PRODUCT CHANGE NOTIFICATION (PCN)

DK-1511-007/B MODULAR CABLE

PCN 20220425_DK-1511-007/B

CHANGE OF DATA SHEET
CHANGE OF DATA SHEET
New Draw.-No. ASS_7160_CArev04

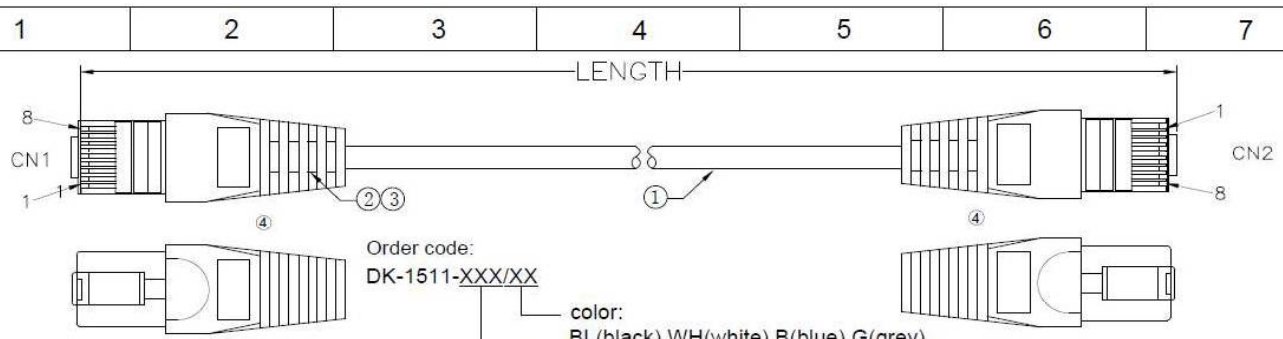
CHANGE OF PRODUCT LOCATION
CHANGE OF PRODUCT LOCATION

NO.	NAME	Q'TY	SPECIFICATION	④	Molding PVC	2	Molding PVC 65P	④	RJ45 CONN	2	RJ45 8P8C, contacts 3u" gold-plated Un-shielded PC UL94V-2	④	CABLE	1	CAT 5E U/UTP(24AWGx1PR)*4+PVC Jacket OD:5.2±0.3mm
NO.	NAME	Q'TY	SPECIFICATION														
④	Molding PVC	2	Molding PVC 65P														
④	RJ45 CONN	2	RJ45 8P8C, contacts 3u" gold-plated Un-shielded PC UL94V-2														
④	CABLE	1	CAT 5E U/UTP(24AWGx1PR)*4+PVC Jacket OD:5.2±0.3mm														
FOR DETAIL, PLEASE TAKE ATTACHED NEW DRAWING: FOR REFERENCE
